Docket No. 70-1308

SUBJECT: QUALITY ASSURANCE (QA) INPUT TO THE SAFETY EVALUATION
REPORT (SER) APPLICABLE TO OPERATIONS AT THE
GENERAL ELECTRIC MORRIS SPENT FUEL SERVICES OPERATION

SAFETY EVALUATION REPORT
SPENT FUEL SERVICES OPERATION
QUALITY ASSURANCE PLAN

Figure 1. Morris Operation Organization

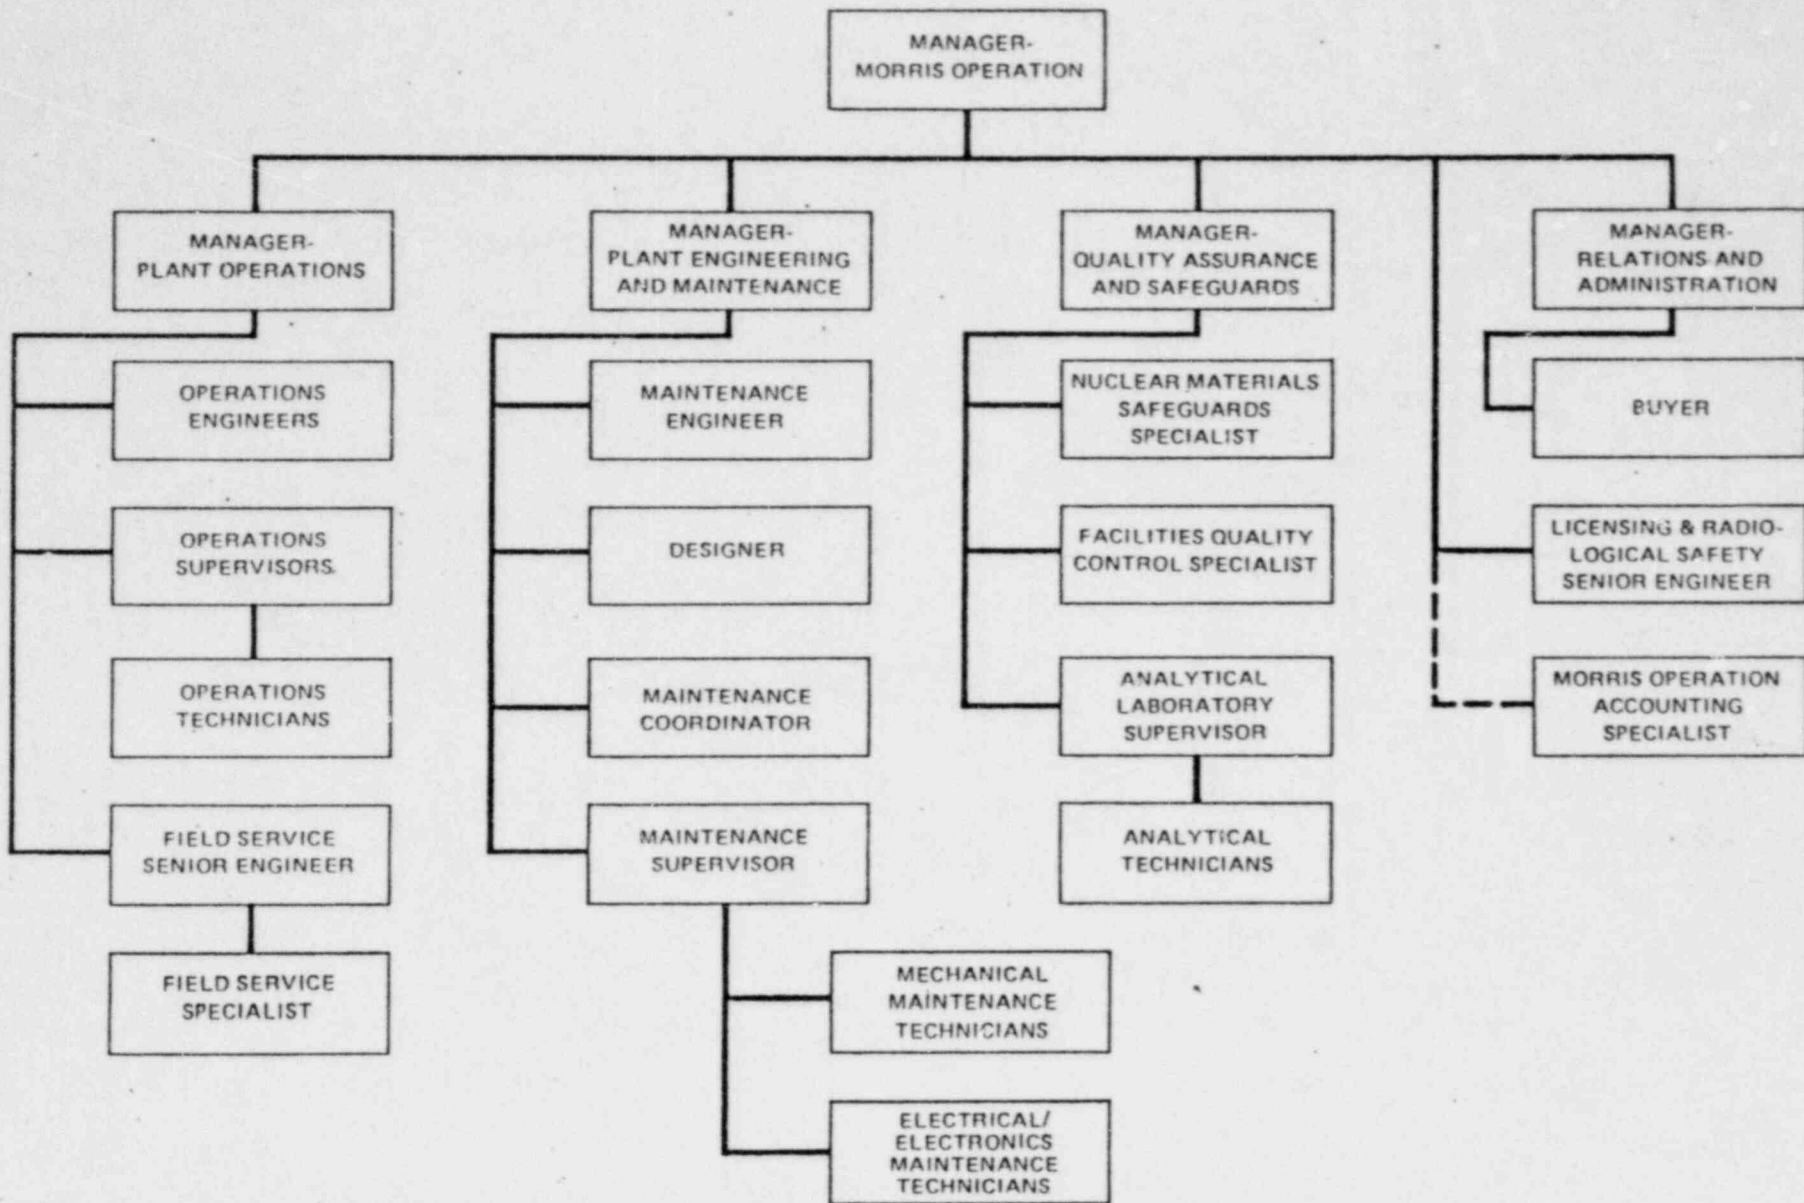
The organizational structure responsible for the establishment and execution of the QA program for the SFSO is shown in Figure 1. The Manager of SFSO, who has the overall responsibility for engineering services and regulatory operations for the Morris facility, has delegated the authority for implementation and control of the QA program to the Manager of QA.

Figure 2 Morris Operation Organization

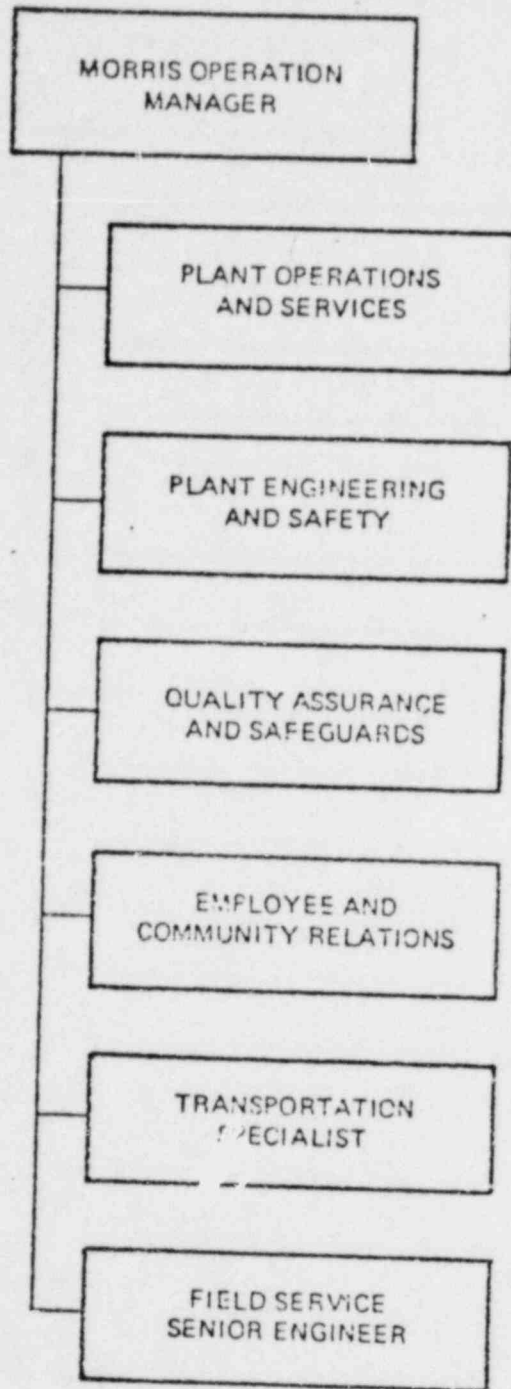
The Morris Operation Organization is shown in Figure 2. The Manager of Quality Assurance and Safeguards, who reports to the Morris Operation Manager, is responsible for directing and managing the QA program at the site. Both

Figure 3. Quality Assurance and Safeguards Organization (Morris Operation)

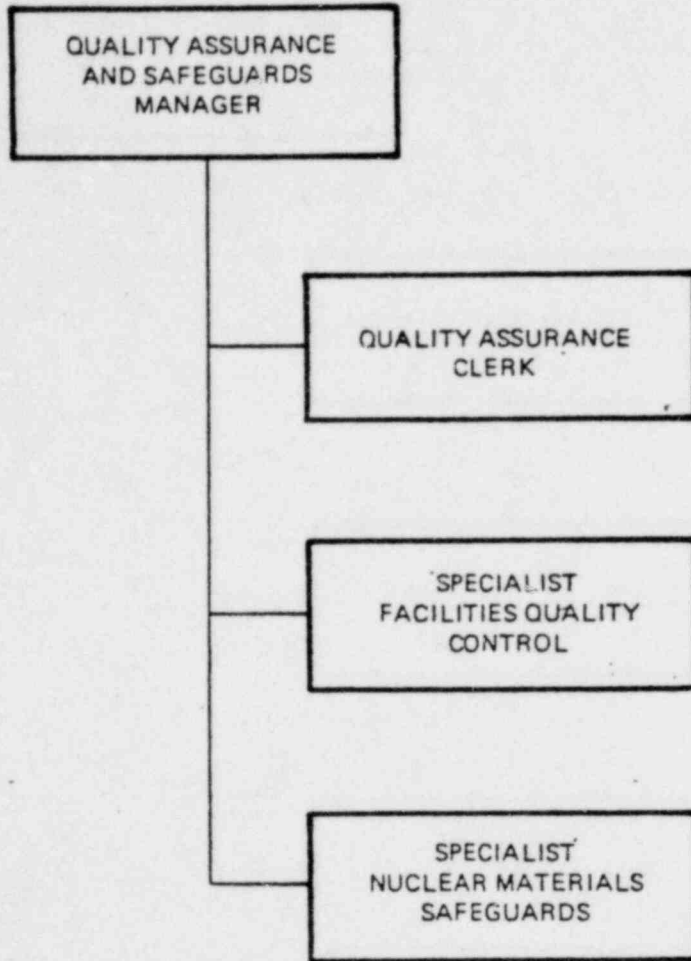
QA organizations have authority delegated in writing from the manager SFSO and freedom to identify quality problems; initiate, recommend or provide solutions; and verify implementation of solutions. The QA personnel shown in Figure 3 and assigned to the Morris Operation is sufficient to support the level of activity expected at the site.
